# Access Compliance Report

## Public Rights-of-Way

### (Curb Ramps)

Intersection ID: 23444	Main Street: TRAVELERS_CT	Cross Street: PROVIDENCE_LN_WEST	Location: W
ADA ID: 367C044E9E9C	Ramp Type: PerpDiag	Initial Pass/Fail: Fail	Overall Compliance: No
Severity Score: 21.25			
Codes/Mitigation Info/Possible Solution		Field Measurements/Component Compliance

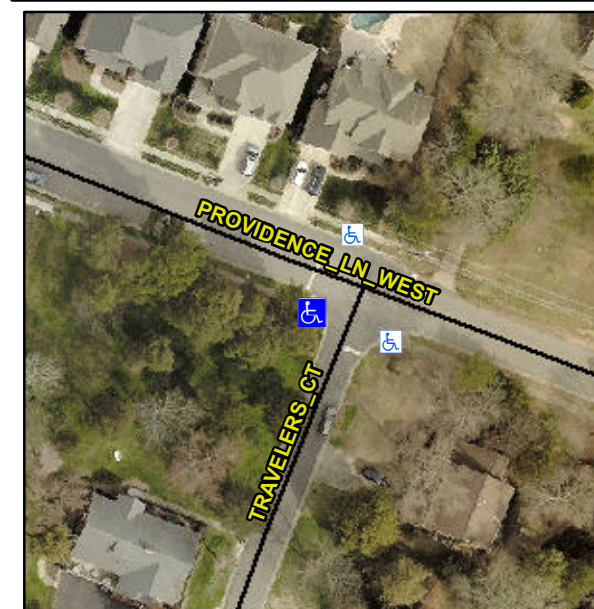
**Not Found, R304.5.1, R304.2.2**

Compliance	Description	Data	Compliance	Description	Data
N/A	Ramp Length (in)	73.0	No	Ramp Slope (%)	10.2
No	Ramp Width (in)	47.0	Yes	Ramp XSlope (%)	1.7
N/A	Flare Type LT	N/A	N/A	Flare Type RT	N/A
N/A	Flare Slope LT (%)	N/A	N/A	Flare Slope RT (%)	N/A
N/A	Flare Traversable LT?	N/A	N/A	Flare Traversable RT?	N/A
N/A	Landing Length (in)	N/A	N/A	DWS Provided?	N/A
N/A	Landing Width (in)	N/A	N/A	DWS Contrast?	N/A
N/A	Landing Slope (%)	N/A	N/A	DWS Length (in)	N/A
N/A	Landing X Slope (%)	N/A	N/A	DWS Full Width?	N/A
N/A	Landing Curb? (Y/N)	N/A	N/A	DWS Offset (in)	N/A
N/A	Shared Landing?	N/A			
N/A	Gutter Ponding?	N/A	N/A	Gutter Slope (%)	N/A
N/A	Gutter Lip Ht (in)	N/A	N/A	Gutter X Slope (%)	N/A
N/A	Painted X Walk1?	No	N/A	Painted X Walk2?	No
	X Walk 1 Direction	To SE		X Walk 2 Direction	To NE
N/A	X Walk 1 Width (in)	N/A	N/A	X Walk 2 Width (in)	N/A
	X Walk 1 Slope (%)	0.6		X Walk 2 Slope (%)	4.3
	X Walk 1 X Slope (%)	3.1		X Walk 2 X Slope (%)	0.3

**Remove & Replace Curb Ramp With Two New Directional Ramps or Equivalent.**
